REQUEST FOR TECHNICAL CHANGE

AGENCY: Building Code Council

RULE CITATION: 2018 NC Residential Code, R4603.6

**FIGURE R4603.6(c)  
PILING NOTCHED MORE THAN 50%**

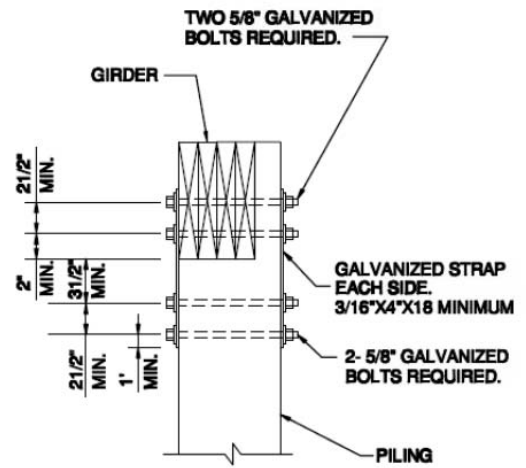
Figure 4603.6(c):

*There do not appear to be any changes to this Figure from what is currently in the Code. Please confirm this is correct.*
